City of Carlisle, Iowa
Planning and Zoning Commission
Regular Meeting
June 21, 2021
7:00 P.M.
City Council Chambers – 100 N. 1st Street

Carlisle Commons - Final Plat

Danamere Farms Plat 9 - Final Plat

Danamere Farms Plat 10 - Final Plat

DANAMERE FARMS PLAT 9 CARLISLE, IOWA **FINAL PLAT**

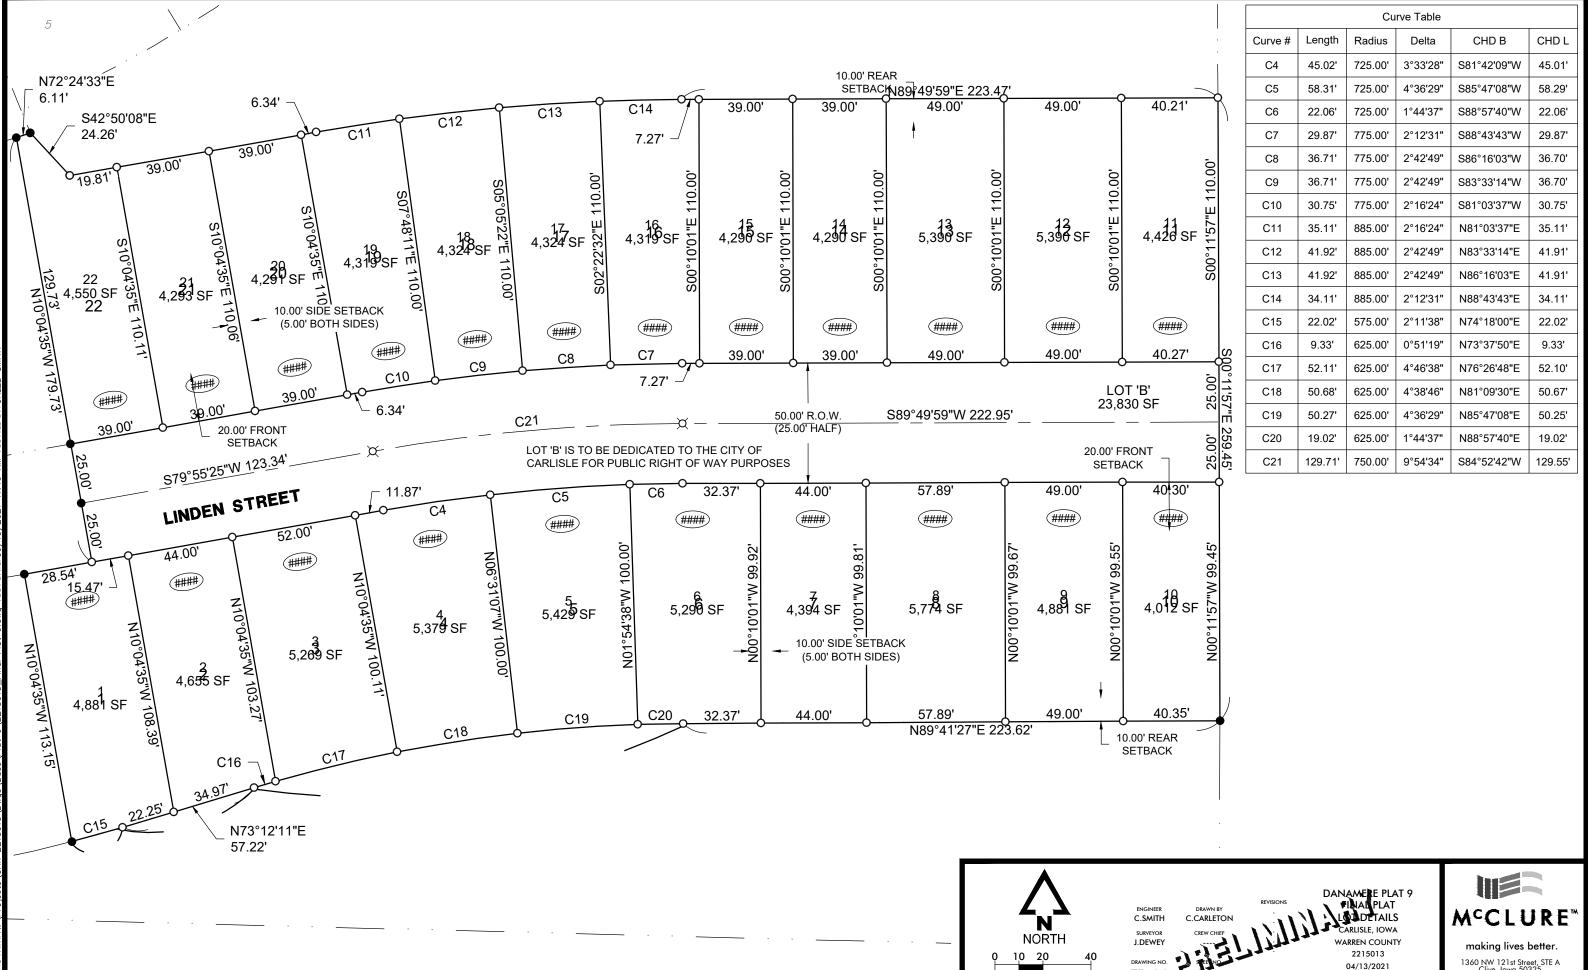
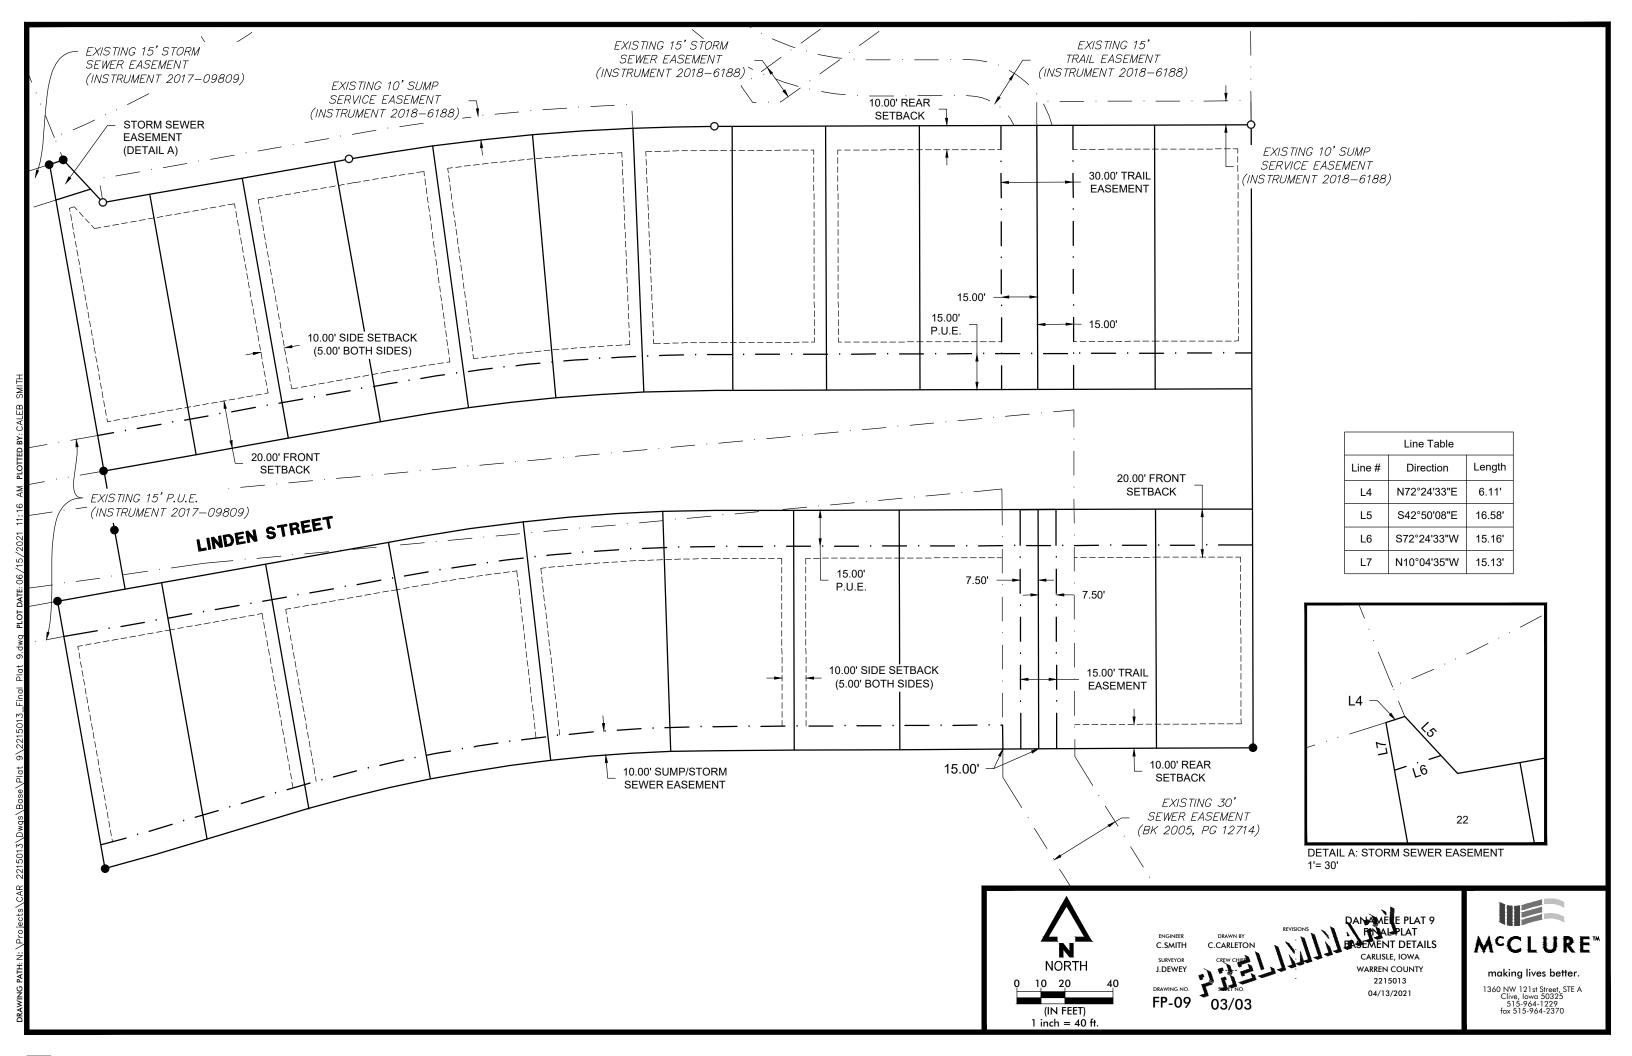
- c. On Page 2, the outer boundary dimension along the northerly line of Lots 19-22 is still missing. The plat is now also missing outer dimensions outside Lots 16-19 and 3-6.

- d. Lots 1-21 have double lot number labels.
- e. Setback lines are missing on Page 2 to go with existing setback labels.
- f. Move setback labels so they do not overlap other text.
